Report of Staff Recommendation

File No.: 4-D-22-TOB

Request: BUILDING PERMIT

Project: Law Family Dentistry – 10850 Hardin Valley Rd

CONCEPT LAYOUT DRAWING

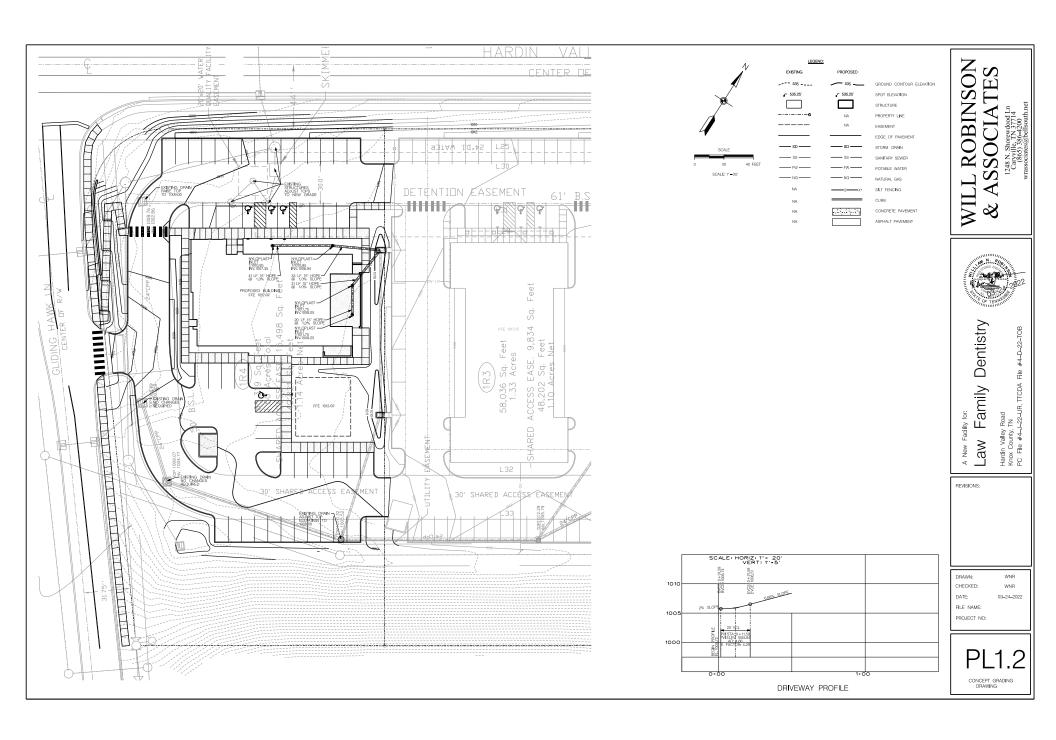
- 3) The site is located at the southeast corner of Hardin Valley Road and Gliding Hawk Lane. This is the last parcel to be developed on this block. There is a curb cut located mid-block on Hardin Valley Road that provides access to three properties on the west side of this block. The two adjacent developments contain drive aisles that align with each other at the front of the sites to provide inter-development connectivity. The site plan proposes another front drive aisle that will align with those of the neighboring developments to foster continuity and facilitate access to those sites off of Gliding Hawk Lane. The applicant is requesting a waiver from the front parking lot setback in order to align the front drive aisle and parking with those that are adjacent to add an access point off of Gliding Hawk Lane that could serve multiple properties. Staff supports this waiver to allow for better consistency and connectivity within this block.

- 4) The proposed ground area coverage (GAC), Floor Area Ratio (FAR), and Impervious Area Ratio (IAR) are in compliance with the Design Guidelines.
- 5) Parking is proposed throughout the site in front of the dentist office, behind the dentist office, and around the Phase 2 building site. The site plan proposes to include the parking and drive aisles for both phases to complete the vehicular path through the site and provide access to neighboring properties. Therefore, plans for Phase 2 would be for the building only unless

6) The TTCDA Guidelines requires between 24 and 35 spaces, and the County Zoning Ordinance requires a minimum of 43 spaces with no maximum. The applicant is requesting a waiver from the TTCDA parking requirements to comply with the parking requirements of the Knox County Zoning Ordinance and is proposing 52 spaces.

- **Waivers and Variances** 1) Waiver to reduce the front parking lot setback to 6 feet.
 - 2) Waiver to increase the allowed parking spaces to 52 spaces.

- 1) Approve the waiver to reduce the front parking lot setback to 6 feet so it is consistent with adjacent development and will allow the drive aisles to connect.
- 2) Approve the waiver from the TTCDA parking standards to increase the allowed parking spaces from 35 to 52 to allow the applicant to comply with Knox County zoning regulations.

PHOTOMETRIC PLAN

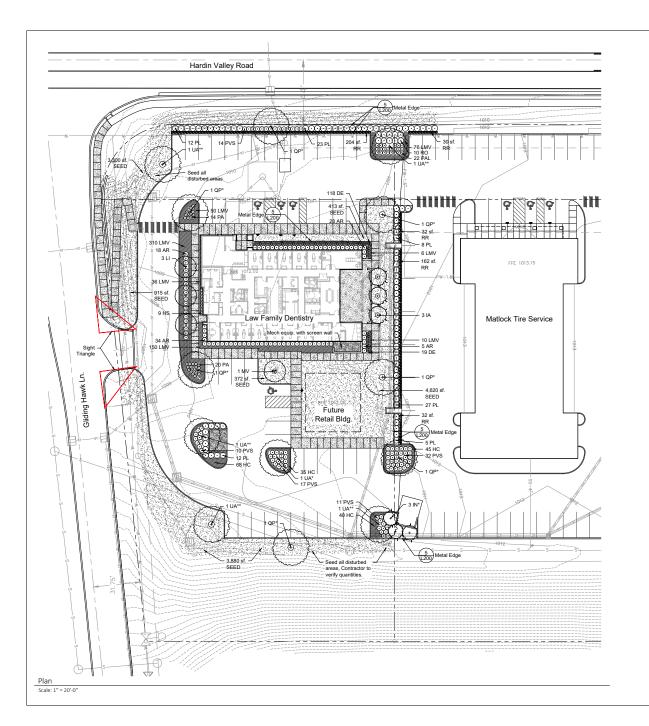
- 8) The proposed lighting includes six light poles at the edges of the parking areas and and building-mounted lights around the perimeter of the front and right side facades for security. Full cut-off light fixtures are proposed that utilize LED lighting and thereby meet the TTCDA Guidelines. Lighting levels likewise meet the TTCDA Guidelines.
